**Petition 22-11
Tim Raymond on Behalf of TMF Plastic Solutions, LLC
Site Plan Approval**

ENGINEERING PLANS FOR TMF MANAGEMENT, LLC PARKING ADDITION

Subject: 12127B Galena Road TMF Management South Parking Lot Addition
(WBK Project 19-102.AK)

RE: *Site Plan Approval for Building Addition*
12127 Galena Road, Unit B, Plano, Little Rock Township (PIN # 01-01-200-002)

TMF MANAGEMENT, LLC PARKING ADDITION
CIVIL SITE PLAN

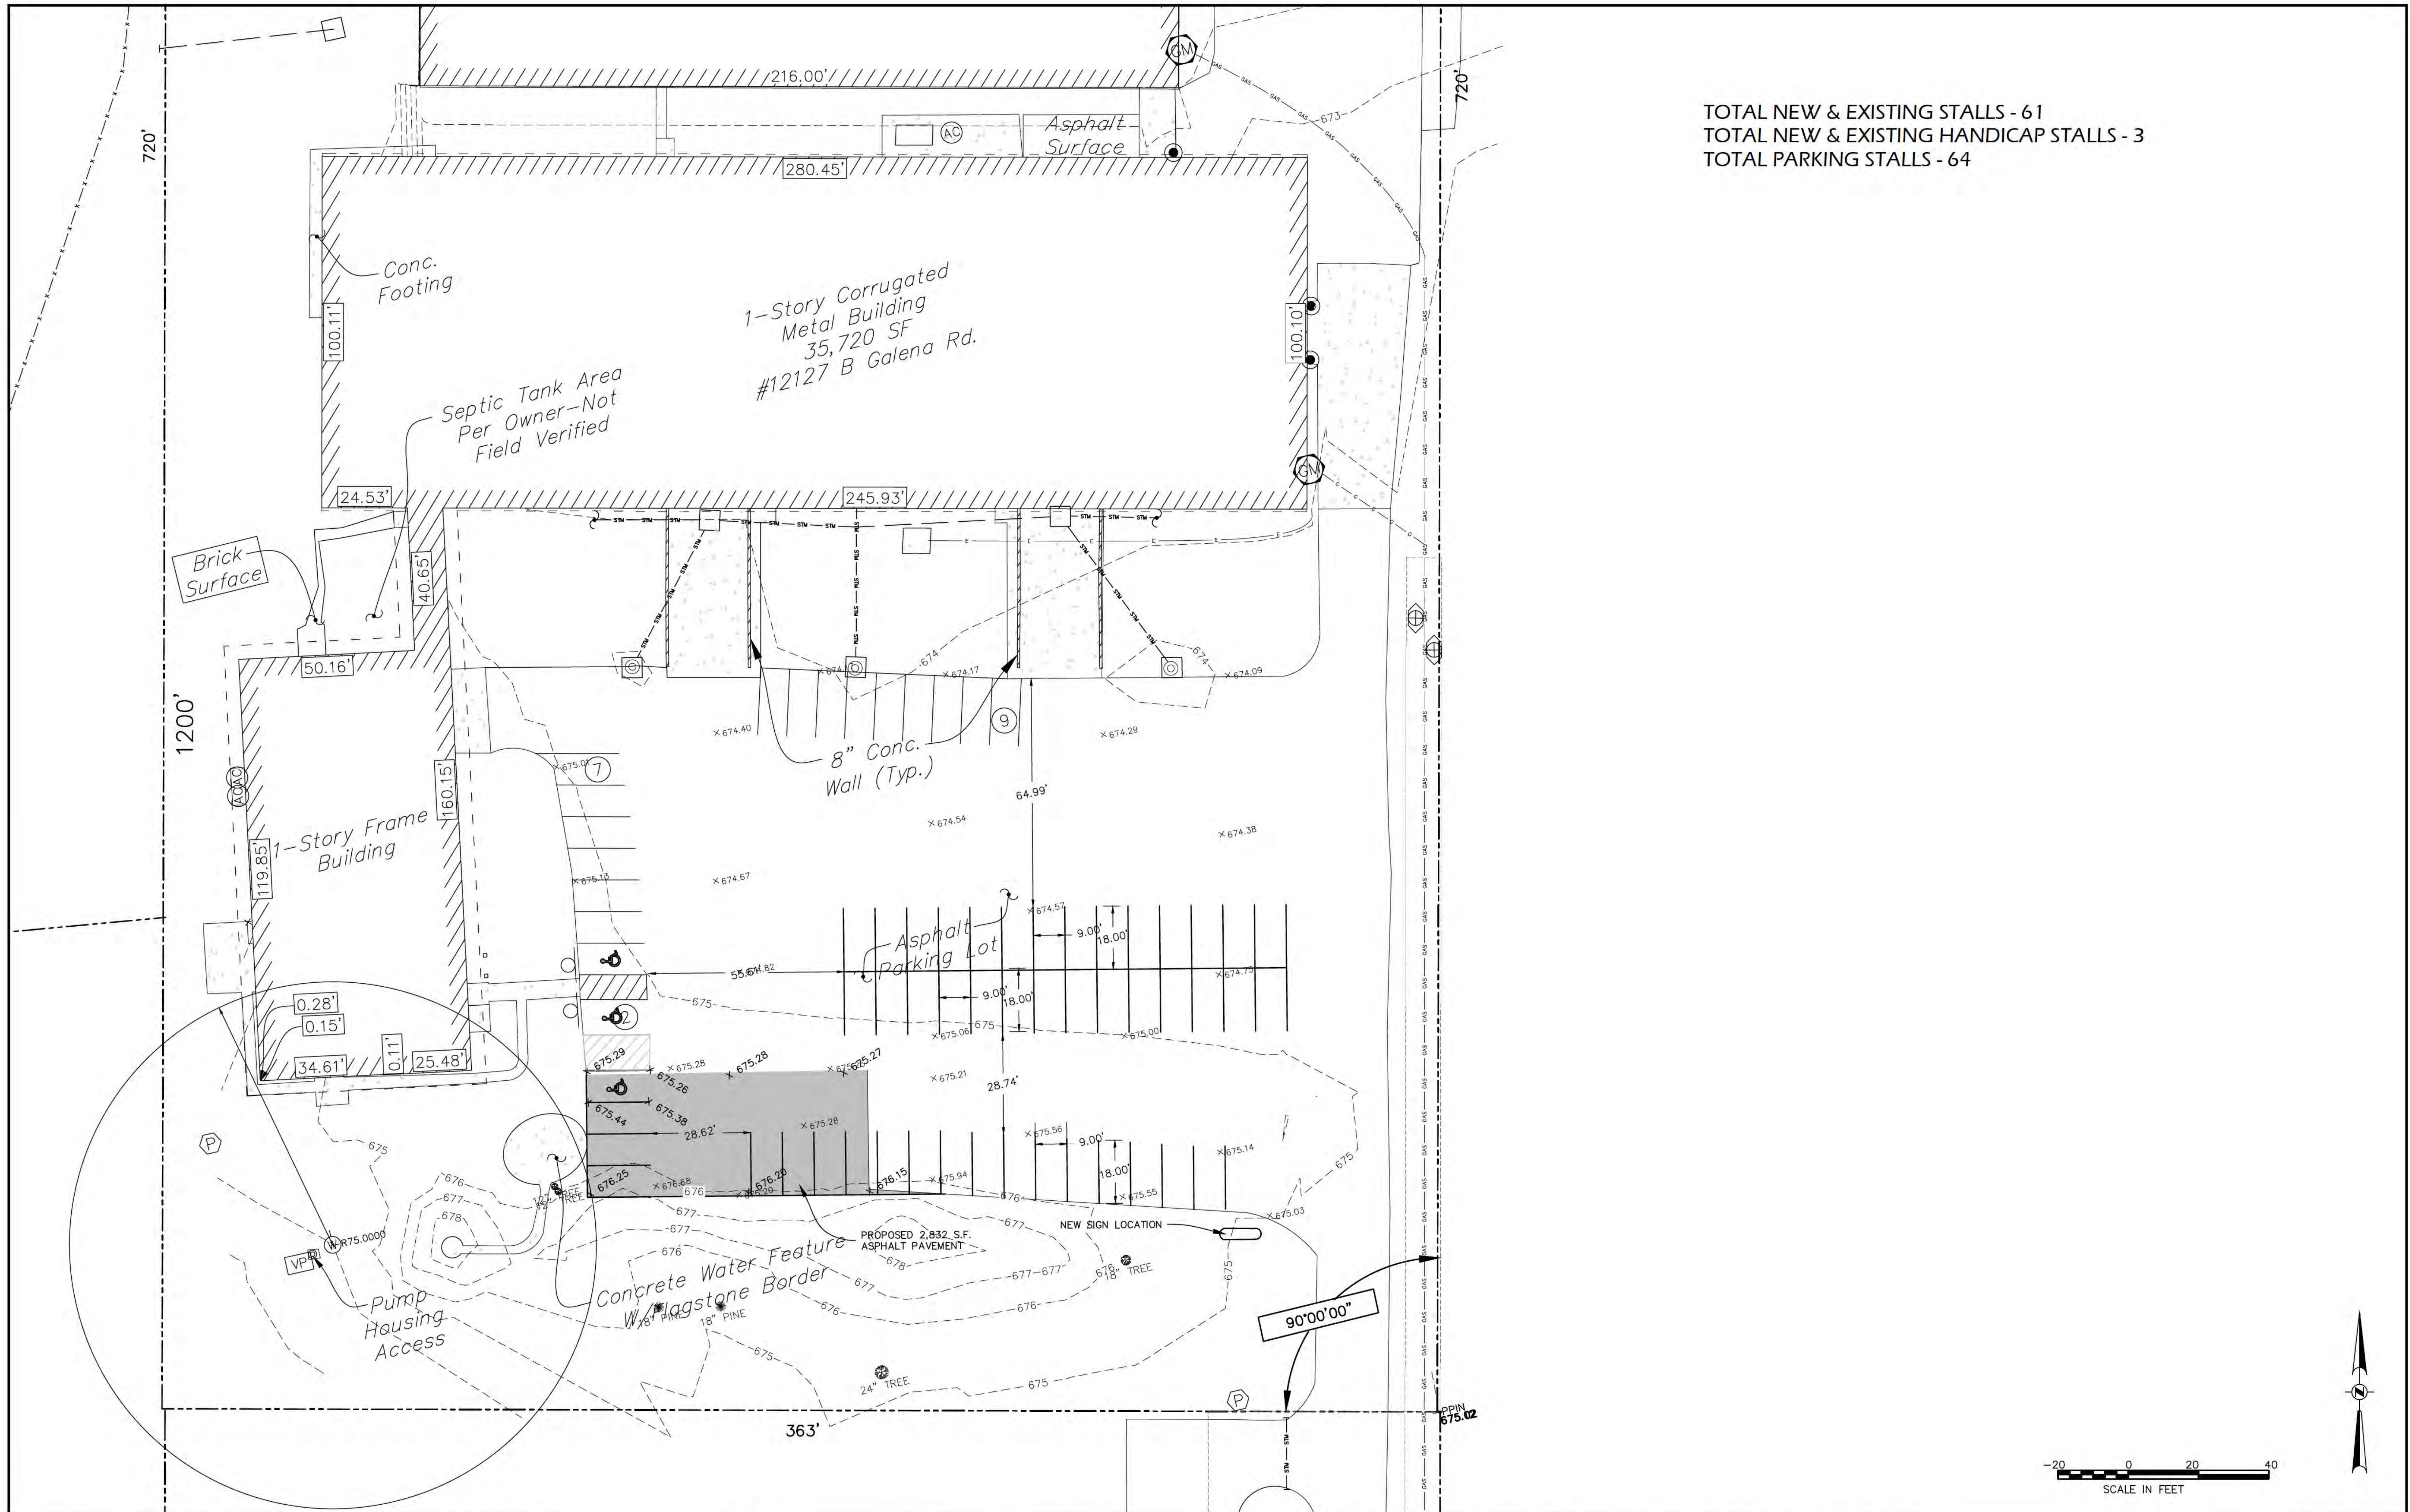
*Traffic and Parking Layout-Site plans should minimize dangerous traffic movements and congestion, while achieving efficient traffic flow. An appropriate number of parking spaces shall be provided while maintaining County design standards. The number of curb cuts should be minimized and normally be located as far as possible from intersections. Connections shall be provided between parking areas to allow vehicles to travel among adjacent commercial or office uses. Cross-access easements or other recordable mechanisms must be employed. **The property already possesses access off of Galena. The property presently has thirty-eight (38) parking spaces including two (2) handicapped parking space which will be increased to sixty-four (64) parking spaces including three (3) handicapped parking spaces***

We find the fee-in-lieu calculations and engineering plans to be acceptable. Contact our office prior to construction of the parking area to verify erosion control measures.
